Product Change Notification / ALAN-18KFQO196

CCB 6017 Initial Notice: Qualification of MMT as an additional assembly site for selected AT24Cxx device family available in 8L TSSOP (4.4mm) package.

PCN# ALAN-18KFQO196

CCB 6017
Pre and Post Change Summary
PCN# ALAN-18KFQO196

ANAP

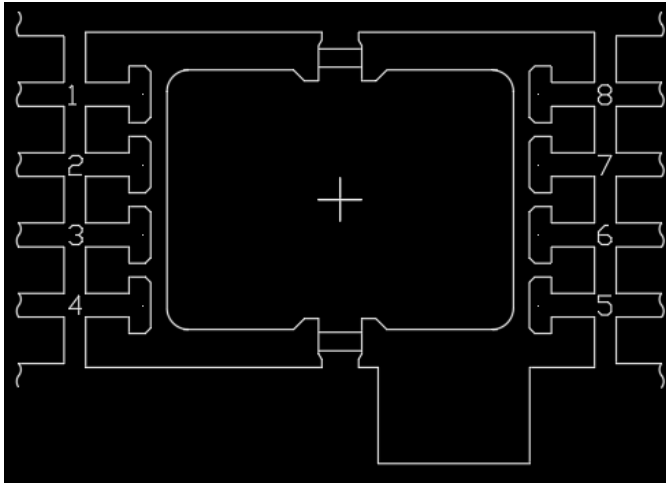
Bond Wire Material	PdCu
Die Attach material	8290
Mold compound material	G700A
Lead-Frame Paddle Size	98 x 87 mils

ASSH

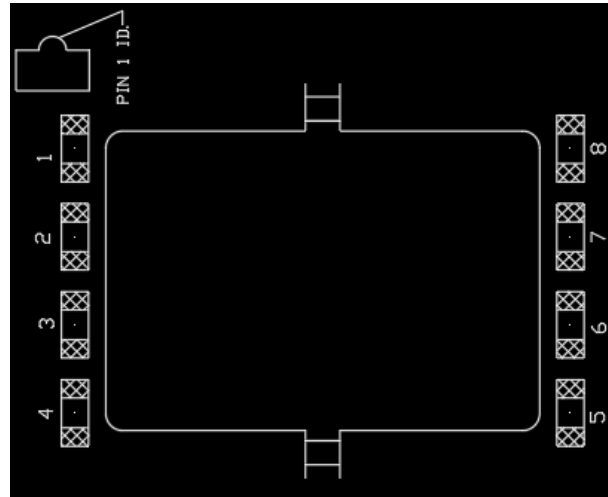
Bond Wire Material	PdCu
Die Attach material	EN-4900G
Mold compound material	G700LY
Lead-Frame Paddle Size	126 x 87 mils

MMT

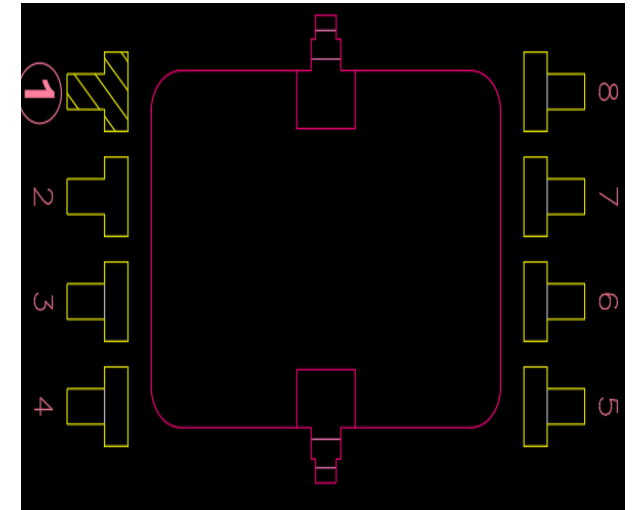
Bond Wire Material	Au
Die Attach material	2200D
Mold compound material	G600V
Lead-Frame Paddle Size	118 x 87 mils
